Access Compliance Report

Public Rights-of-Way

Intersection ID: 26032	Main Street: CABOT_CR	Cross Street: CARMEL_COMMONS_BV	Location: NE
ADA ID: A81E04597FB2	Ramp Type: PerpDiag	Initial Pass/Fail: Fail	Overall Compliance: No
		Severity Score: 50

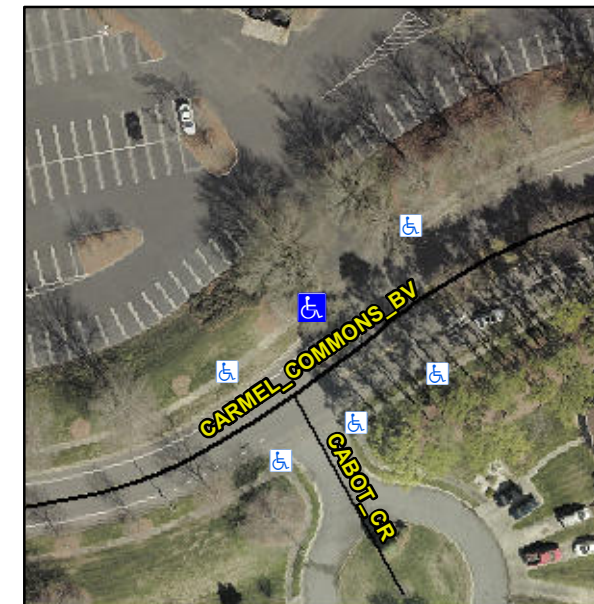
Not Found, R304.2.2, R304.5.3

Compliance	Description	Data	Compliance	Description	Data
N/A	Ramp Length (in)	58.0	No	Ramp Slope (%)	19.9
Yes	Ramp Width (in)	53.0	No	Ramp XSlope (%)	10.4
N/A	Flare Type LT	N/A	N/A	Flare Type RT	N/A
N/A	Flare Slope LT (%)	N/A	N/A	Flare Slope RT (%)	N/A
N/A	Flare Traversable LT?	N/A	N/A	Flare Traversable RT?	N/A
N/A	Landing Length (in)	N/A	N/A	DWS Provided?	N/A
N/A	Landing Width (in)	N/A	N/A	DWS Contrast?	N/A
N/A	Landing Slope (%)	N/A	N/A	DWS Length (in)	N/A
N/A	Landing X Slope (%)	N/A	N/A	DWS Full Width?	N/A
N/A	Landing Curb? (Y/N)	N/A	N/A	DWS Offset (in)	N/A
N/A	Shared Landing?	N/A			
N/A	Gutter Ponding?	N/A	N/A	Gutter Slope (%)	N/A
N/A	Gutter Lip Ht (in)	N/A	N/A	Gutter X Slope (%)	N/A
N/A	Painted X Walk1?	No	N/A	Painted X Walk2?	No
	X Walk 1 Direction	To S		X Walk 2 Direction	To NE
N/A	X Walk 1 Width (in)	N/A	N/A	X Walk 2 Width (in)	N/A
	X Walk 1 Slope (%)	5.7		X Walk 2 Slope (%)	0.8
	X Walk 1 X Slope (%)	1.4		X Walk 2 X Slope (%)	6.0

Remove & Replace Curb Ramp With Two New Directional Ramps or Equivalent.
